L83X-  
A.03.14

**To:** Official After Sales Network  
**Subject:** Cross member bolts.  
**Date:** 14<sup>th</sup>/03/2014  
**Pages:** 4

Cross member bolts.

All Lamborghini Aventador Coupè & Roadster LP700 Model Year **12,13** and **14** From VIN **CLA00091** to **ELA02427**.

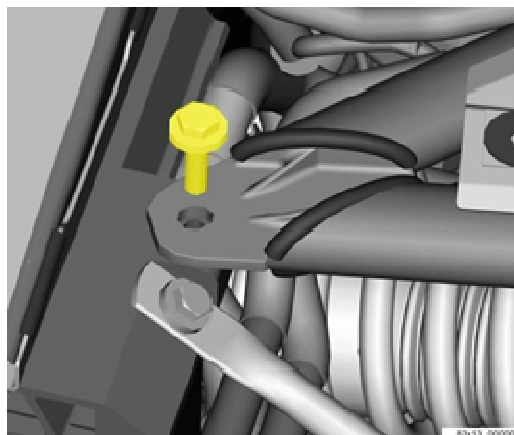
8. Unscrew and replace engine cross member side bolts with new green coloured thread-locker ones (p/n N0195306).

Bolt tightening.

Pressure torque: **27 Nm ± 10%**.

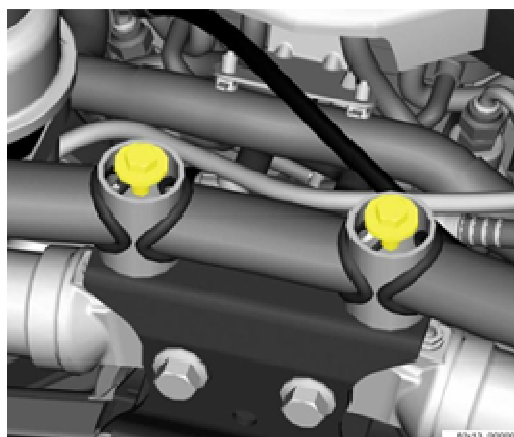
9. Replace 2 central bolts with pink threadlocker ones.

Bolt tightening.

Pressure torque: **27 Nm ± 10%**.
